# **Some comments on the loss of the trawler Gaul and the re-opened Formal Investigation**

## **Some comments on the loss of the trawler Gaul and the re-opened Formal Investigation**

**REPORT OF THE RE-OPENED FORMAL  
INVESTIGATION INTO THE LOSS OF  
THE FV GAUL**

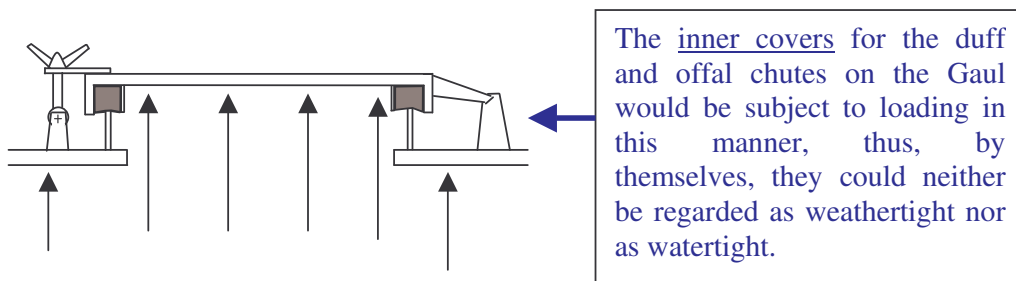
**Weathertight fitting:** In the sketch below, water pressure tends to force the gasketed steel plate into the closed position and this compresses the gasket and prevents leakage. The fitting's clips and hinges are somewhat redundant when the fitting is loaded in this way. The fitting is strong and resistant to water pressure loads from the outside:

If the pressure is reversed on this same fitting, the gasketed plate will tend to lift and allow water leakage. The fitting's clips and hinges will also take the full force of the water pressure loading. The fitting is relatively weak when faced with water pressure loads from the inside:

#### **2.1 Arrangements provided on the Gaul: cross-sections through the vessel's side in way of the duff/offal chute openings (looking forward) showing their design and operation during rubbish discharge:**

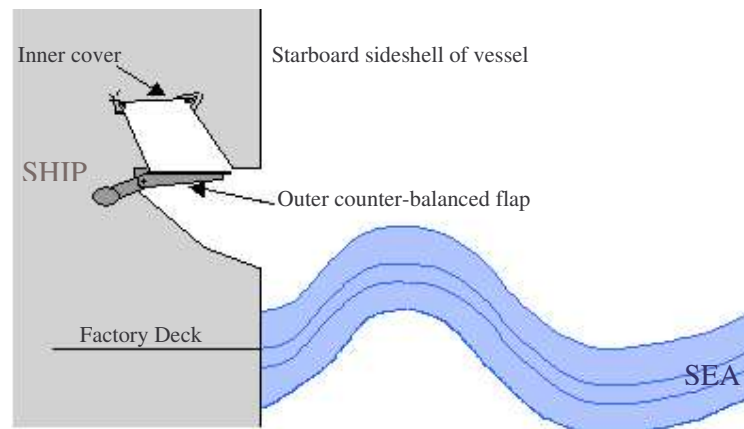
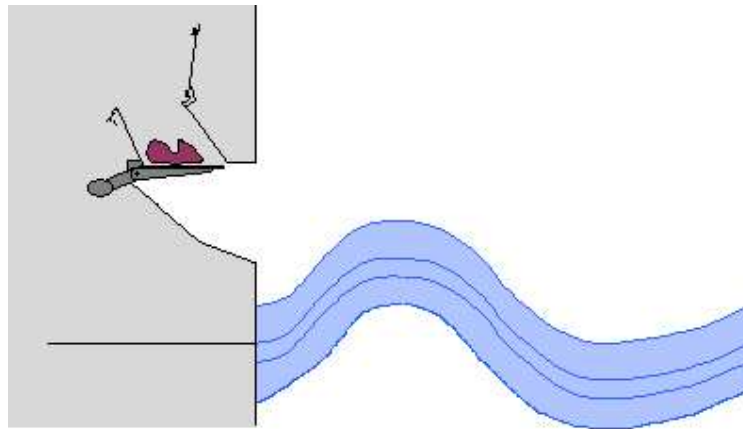
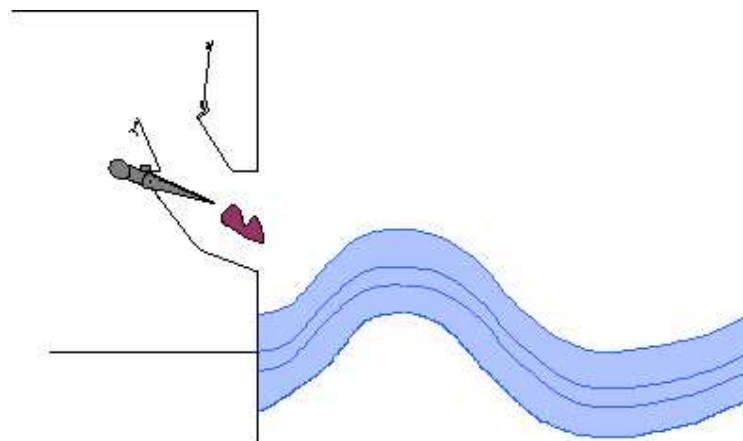
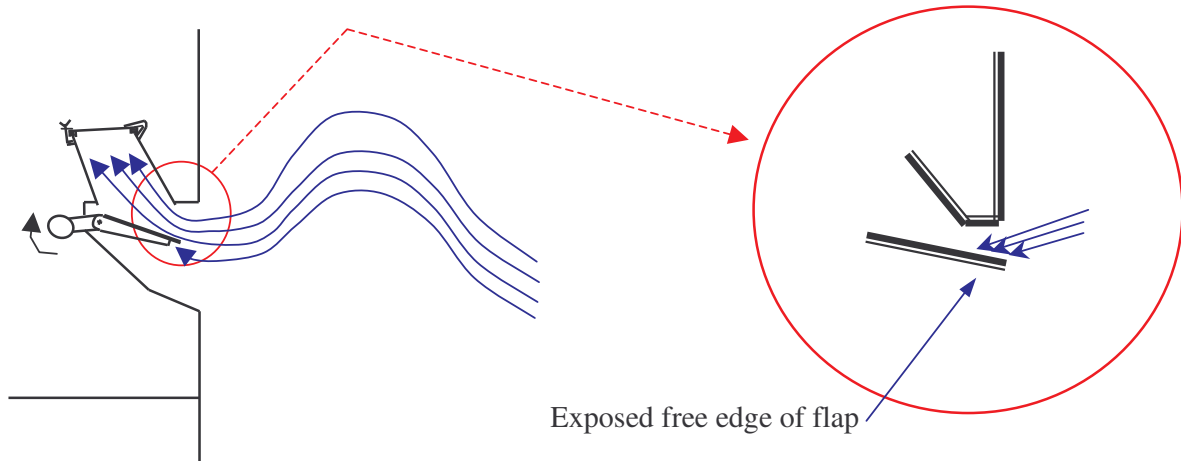
In the above arrangement, the outer counter-balanced flap provides the primary strength barrier (when it is closed) and this is capable of taking the full force of the sea. However, the non-return flap is not wholly weathertight and water can leak past this flap. The hinged inner cover, on the other hand, is not meant to take the full force of the sea (it is not strong enough) but it will prevent water that has leaked past the non-return flap from entering into the ship's factory space.

In order to assure the watertight integrity of the hull, it is necessary for both the non-return flap to be closed and for the inner cover to be closed and secured correctly.

If, for any reason, the flap was not fully closed (e.g. if an accumulation of offal remnants or stiffness in the hinges had prevented it from closing completely), the sea could act directly on the exposed free edge of the flap and push it open.

In rough weather, this could subsequently allow the full force of the sea to impact on the relatively weak hinged inner cover.

For correct 'non-return' operation, a flow of seawater into the chute should always force the non-return flap plate into the closed position. However this was not the case on the Gaul. The design of the non-return flap arrangement on the Gaul is therefore deficient and it could be expected to malfunction during normal service.

## 2.2 Considering two slightly different constructional arrangements for the duff and offal chutes, in which the design fault is not present and in which the non-return flap could be expected to function correctly:

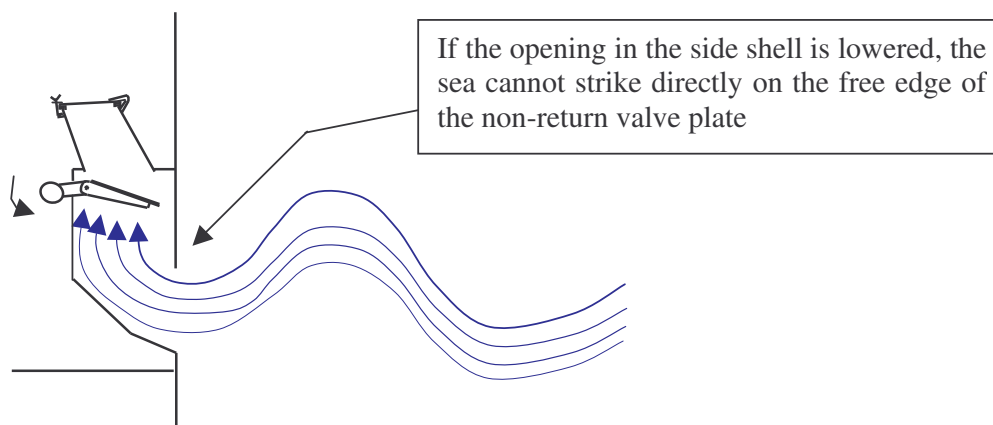
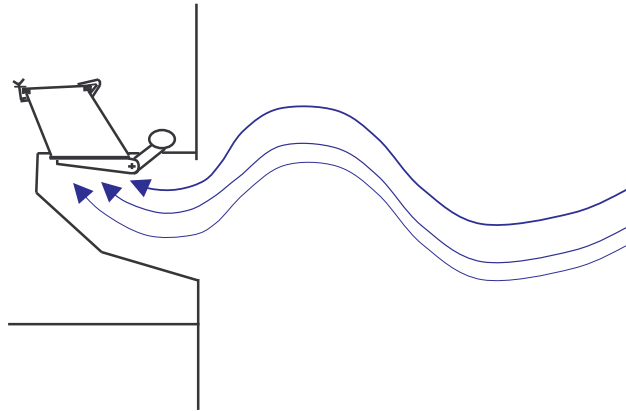
Sketches 2.2.a) and 2.2.b) below, show that with slightly different constructional arrangements (to those provided on the Gaul) the **design fault** would have been eliminated.

If the position of the opening in the side shell were lowered (or alternatively if the chute and hopper construction were raised inside the factory space) so that the free edge of the non-return flap was not exposed to direct wave impact then the non-return flap would function as required.

a) For the arrangement shown below, the action of the sea would always tend to close the non-return flap:

- b) The more usual arrangement, however, and one which is commonly found within the fishing industry, is that where the orientation/direction of the opening for the flap is reversed.

In this case, again, the direct action of the sea will always tend to close the flap:
